# \*MANDATORY SERVICE BULLETIN\*

**NUMBER:** SB11-03 **REVISION:** 00 **DATE:** 03/16/2011

## **SUBJECT: ENGINE INLET SHROUD MODIFICATION**

KODIAK 100 Series Aircraft Serial Numbers: 100-001 through 100-047.

Figure 1-1 — Right Shroud Receiver Removal

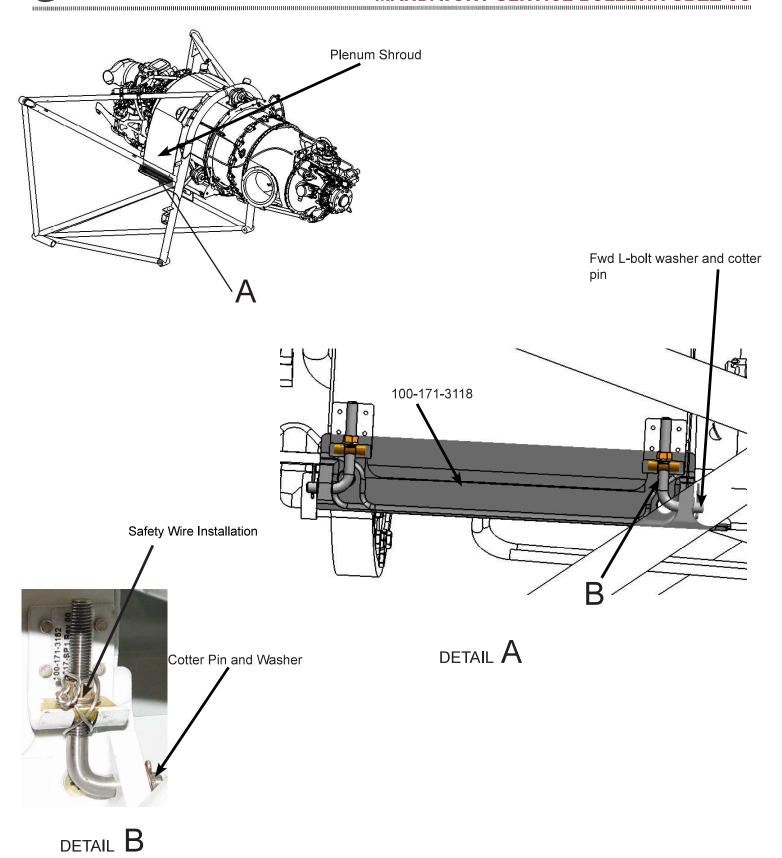
- Remove the safety wire attached to each L-bolt (P/N 100-171-3161). Refer to Figure 1-1, Detail B.
- 2. Follow the plenum shroud removal instructions in the **KODIAK 100 Maintenance Manual Chapter 71**, **Power Plant** to detach the plenum shroud from the right shroud receiver (P/N 100-171-3118). Refer to **Figure 3-1**.
- 3. Remove the cotter pin (P/N MS24665-134) and washer (P/N NAS1149F0432P) from the forward L-bolt (P/N 100-171-3161). Refer to Figure 1-1, Detail A.

4. Remove the two (2) screws (P/N MS24693-S272) attaching the right shroud receiver (P/N 100-171-3118) to the aft plenum and remove the right shroud receiver (P/N 100-171-3118) from the aircraft.

- 1. Postion and secure the right receiver (P/N 100-171-3118) using the two (2) screws (P/N MS24693-S272). Refer to Figure 1-1, Detail A.
- 2. Reconnect the fwd L-bolt (P/N 100-171-3161) to the right shroud receiver (P/N 100-171-3118) using the washer (P/N NAS1149F0432P) and a new cotter pin (P/N MS24665-134). Attach the L-bolt (P/N 100-171-3118) assembly to the aft plenum. Refer to Figure 1-1, Detail A.
- 3. Position and reinstall the plenum shroud in accordance with the KODIAK 100 Maintenance Manual Chapter 71, Power Plant.
- 4. Install safety wire around both L-bolts similar to installation shown in Figure 1-1, Detail B.

Figure 2-1 — Right Shroud Receiver Modification

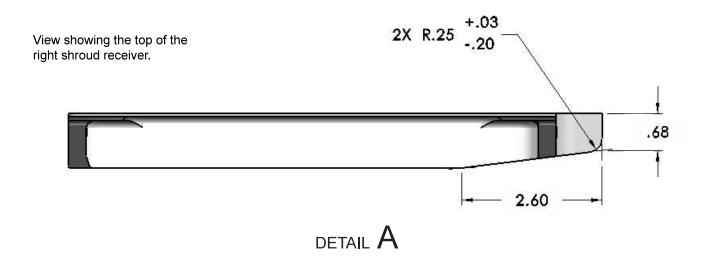
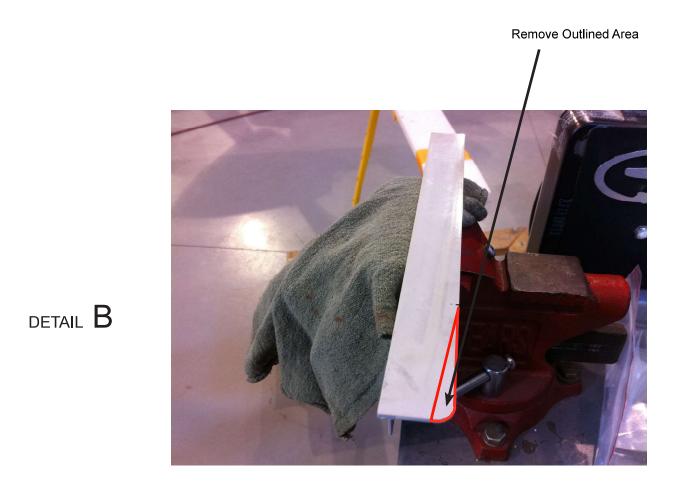
Quest has been notified that the right receiver shroud has been rubbing on the engine mount. Although no significant damage or problem has occurred, the following Service Bulletin is being mandated by Quest.

- Mark the bottom of the right shroud receiver (P/N 100-171-3118) as shown in Figure 2-1, Details A & B.
- 2. Using a grinder or similar tool, remove the area indicated in **Figure 2-1**, **Detail B**. Round and radius the new corners.
- 3. Prime and paint the exposed aluminum. Refer to the bill of materials for recommended products.

Figure 3-1 — Engine Mount Modification

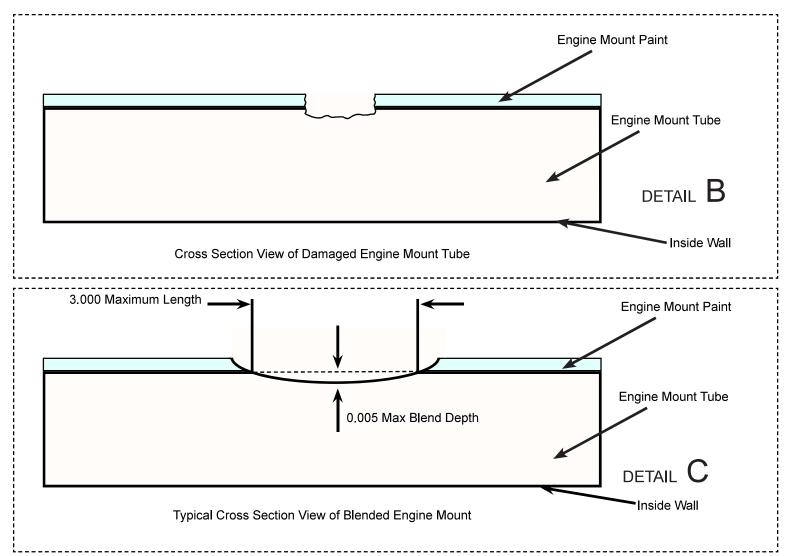
- Inspect the inboard side of the engine mount in the area indicated in Figure 3-1, Detail A.
   If rubbing has occured between the shroud receiver and the engine mount, the area should be inspected for damage to the engine mount structure.
- 2. If damage is found, the affected area should be blended out using an emory cloth, or equivalent tool within the following specifications:
  - Maximum of .005 depth from the engine mount tube outside wall.
  - No longer than 3.000 inches.
  - Less than 1/4 of the circumference of the engine mount tube.
  - Greater than .750 inches from the weld joint.

Refer to **Figure 3-1**, **Detail B & C**. If the blended area does not fit within the above stated specifications, contact Quest for further instructions.

**NOTE:** The paint applied to the engine mount is often very thick. Additional paint may need to be removed in the local area to achieve an accurate reading of the blend depth.

- 3. After blending, inspect the local area for cracks using Penetrant inspection method in accordance with **AC43.13 (Ch. 5, Section 5)**.
- 4. Touch up paint on engine mount in accordance with the **KODIAK 100 Maintenance Manual Chapter 71, Power Plant.**
